# Access Compliance Report

## Public Rights-of-Way

### (Curb Ramps)

Intersection ID: 24503	Main Street: BRUFF_CT	Cross Street: SAINTFIELD_PL	Location: SE
ADA ID: BA8C56159CAE	Ramp Type: Perp	Initial Pass/Fail: Fail	Overall Compliance: No
Severity Score: 21.25			
Codes/Mitigation Info/Possible Solution		Field Measurements/Component Compliance

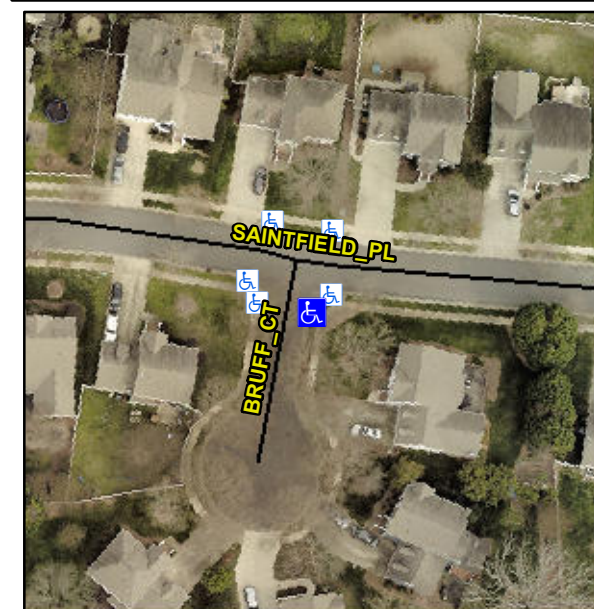
**R304.5.1, R304.2.2**

Compliance	Description	Data	Compliance	Description	Data
N/A	Ramp Length (in)	47.0	No	Ramp Slope (%)	8.8
No	Ramp Width (in)	47.0	Yes	Ramp XSlope (%)	0.9
N/A	Flare Type LT	N/A	N/A	Flare Type RT	N/A
N/A	Flare Slope LT (%)	N/A	N/A	Flare Slope RT (%)	N/A
N/A	Flare Traversable LT?	N/A	N/A	Flare Traversable RT?	N/A
N/A	Landing Length (in)	N/A	N/A	DWS Provided?	N/A
N/A	Landing Width (in)	N/A	N/A	DWS Contrast?	N/A
N/A	Landing Slope (%)	N/A	N/A	DWS Length (in)	N/A
N/A	Landing X Slope (%)	N/A	N/A	DWS Full Width?	N/A
N/A	Landing Curb? (Y/N)	N/A	N/A	DWS Offset (in)	N/A
N/A	Shared Landing?	N/A			
N/A	Gutter Ponding?	N/A	N/A	Gutter Slope (%)	N/A
N/A	Gutter Lip Ht (in)	N/A	N/A	Gutter X Slope (%)	N/A
N/A	Painted X Walk1?	No	N/A	Painted X Walk2?	N/A
	X Walk 1 Direction	To W		X Walk 2 Direction	N/A
N/A	X Walk 1 Width (in)	N/A	N/A	X Walk 2 Width (in)	N/A
	X Walk 1 Slope (%)	0.6		X Walk 2 Slope (%)	N/A
	X Walk 1 X Slope (%)	1.0		X Walk 2 X Slope (%)	N/A

**Remove & Replace Entire Ramp.**
